REVISED RESPONSE TO REQUEST FOR ADDITIONAL INFORMATION

APR1400 Design Certification

Docket No. 52-046

RAI No.: 301-8280

Instrument Loop Diagram for RCS Loop 1 Temperatures

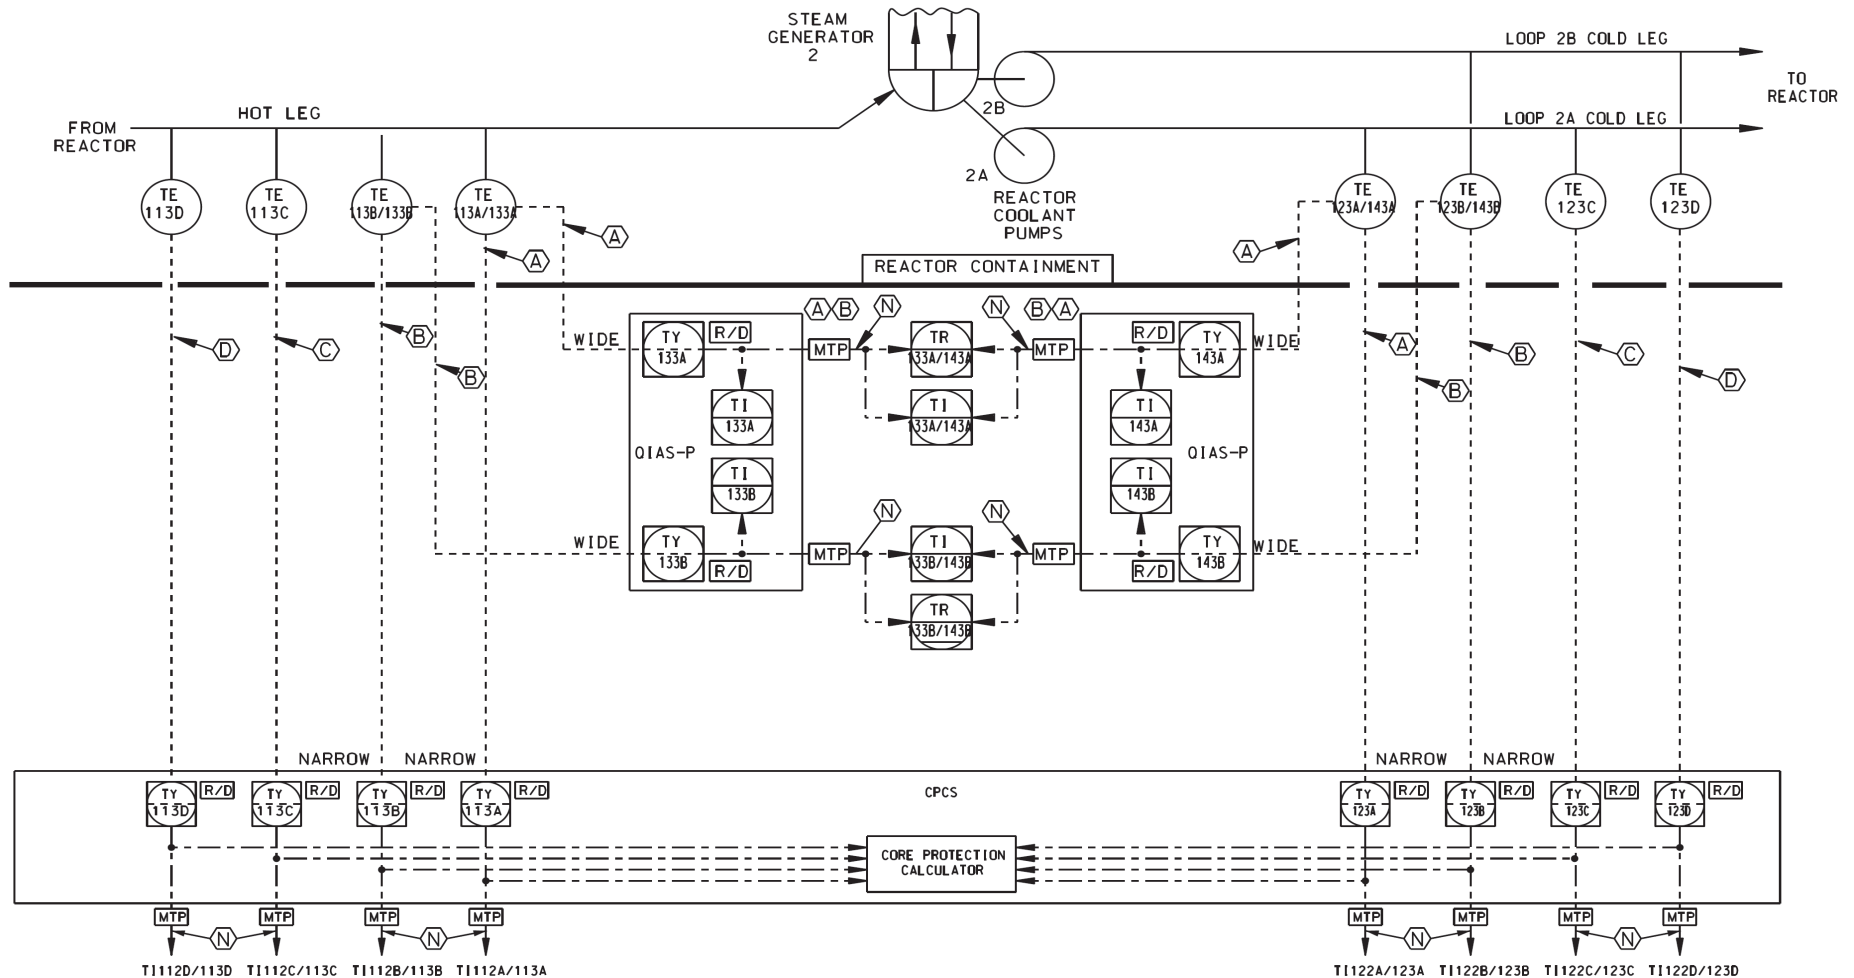
Clarify the hot leg temperature and division description in Table 7.5-1, Accident Monitoring Instrumentation Variables," and describe the geometry of the installed hot leg sensors.

10 CFR 50.55a(h) requires compliance to IEEE Std 603-1991. Clause 4.6 of IEEE Std. 603-1991 requires identification of the minimum number and location of sensors for spatially-dependent process variables. Section A.4 of Technical Report APR1400-Z-J-NR-14001-P states "The number and location of the sensors provided to monitor those variables in Item 4 are given in Tables 7.2-3 ["Reactor Protection System Sensors"] and 7.3-4 ["ESFAS Sensors"] of the DCD. The location of precision RTD for measuring RCS hot leg temperature is assigned to measure appropriate coolant transmission effects by temperature difference and temperature distribution of hot leg." Table 7.2-3 of APR1400 FSAR Tier 2 states there are eight precision RTDs in the hot leg piping which is used by the CPCS for generating high LPD and low DNBR trips. Table 7.5-1 of FSAR Tier 2 states Reactor Coolant Hot Leg Temperature (Wide Range) is a 4 channel, Type B Accident Monitoring Instrumentation Variable, and there are 2 Hot Leg signals per division (QIAS-P). It is not clear to the staff what is meant by "2 Hot Leg signals per division (QIAS-P)" since there are only 2 QIAS-P divisions. Also, provide a diagram of the geometry of the installed hot leg sensors.

In DCD Tier 2, Table 7.5-1, "Reactor Coolant Hot Leg Temperature (Wide Range)," the "Channel Number" column specifies that there are [four \(4\)](#) RTD sensors ([example; T-132A, B and T-133A, B](#)) and [associated channels for the AMI variable](#) assigned to the RCS hot leg [for each steam generator. The four hot leg sensor channels are comprised of two divisions \(example; T-132A and 133A for division A and T-132B and 133B for division B\). The title "Channel Number" in the fourth column will be changed to "Number of Sensors" in order to provide clarity.](#)

Attachment 1 to this response includes the instrument loop diagrams and a physical location drawing which shows the geometry of the installed hot leg sensors.
